Version	Date		Change Reason				Designer	Checker	Approver	DCN I	١0.
V0.41	20140407		Formal First Version				Huqing				
V1.0	20140611		change L3 to another vendor spec. Huqing								
File No.				File Type	SCH	Veichl	e Model				
Part Name			SC00_PEPS_S_KEY					Sheet	of Shee	t 1	of 2
Part No.		PPB-01003-01-00						Drawn By: AMO		DHU	
Company Shenzhen Southern Dare Automotive Electronics Co., LTD

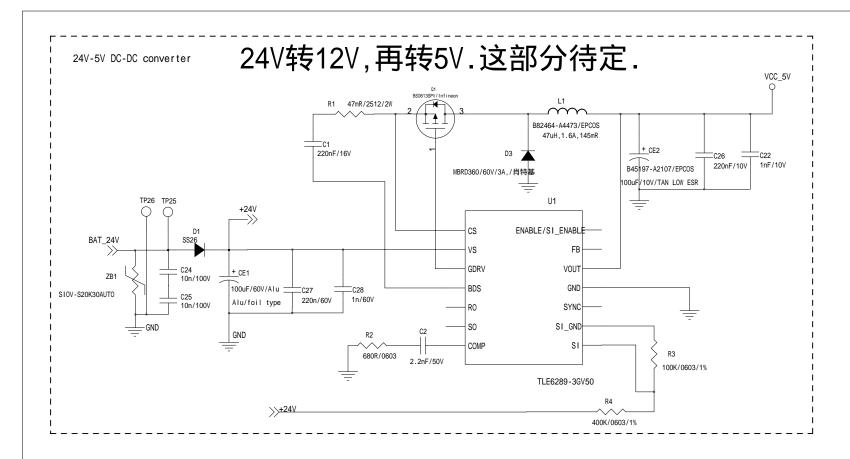
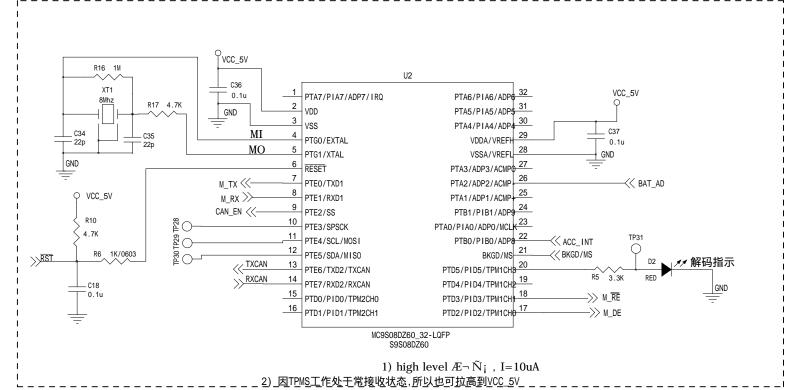
Version change notes list initial version PCBLAYOUT part: V0.2 1) COPPER and hatch changed solider copper 2) Add test point T8/T29/T3 to 3 keys 3) Add silkscreen 1-6 box to bottomside for test record 4) T25 move out silkscreen box 5) T24 cancel, changed gnd hole with mask silkscreen 6) add keepout to battery for mask solder 7) Correct L3 package PIN definition (PIN1/2/3/4) 8) L3 clear to RF antenna. seriously influence RF antenna. so must seperate L3 and RF 9) for layout, L1 right port must be as feed point and C4/C5/C6 must be far from routing betwen feed point and antenna. i.e. keep shortening routing of between PA and antenna feed point as possible 1) two diameter 48MIL hole for locating to 80MIL 2) 4 MARKpoint move away for avoiding location holes. 3) make a panel with 6pcs V0.4 1) only change LF antenna to sumida :CAS13D31-47 2) LF antenna maybe need to debug 1) formal version for pre-production 2) C8 change to connect P12 and GND. p11 directly connect to GND , in order to solve that S-KEY without battery communicates with IMMO V0.41 3) C12=33nH,C11=5.6pF,L1=6.8nH,C4=4.7pF, C6=0 R, C19=0.5pF, C5=R20= NC V1.0 1) only change LF antenna to TOKO SA3D14 (1085BAN-2047=P3), both L3 connecting schematic and L3 package are different

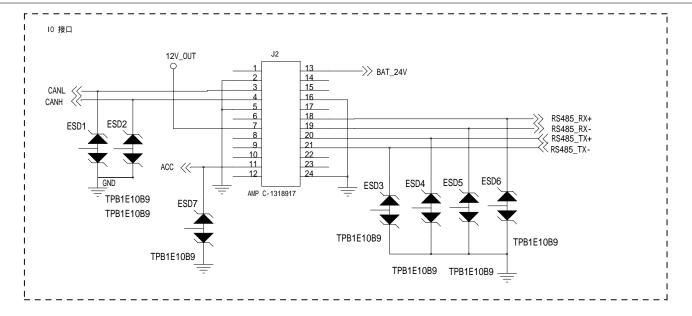
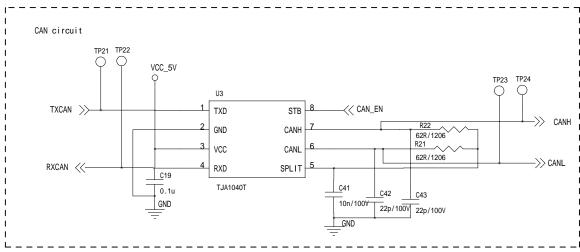
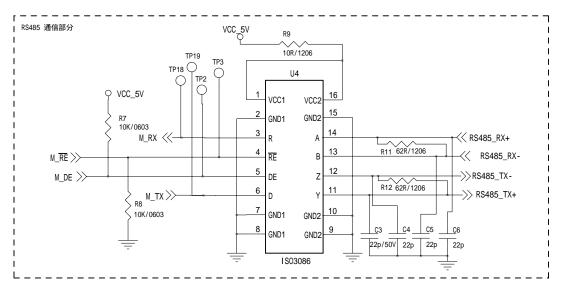
Version	Date		Change Reason				Designer	Checker	Approver	DCN	NO.
V0.41	20140407		Formal First Version				Huqing				
V1.0	20140611		change L3 to another vendor spec.			Huqing					
File No.				File Type	SCH	Veichl	e Model				
Part Name			SC00_PEPS_S_KEY					Sheet	of Shee	et 2	of
Part No.			PPB-01003-01-00					Drawn By: AMOC		NHU	
Company			Shenzhen Southern Dare Automotive Electronics Co., LTD
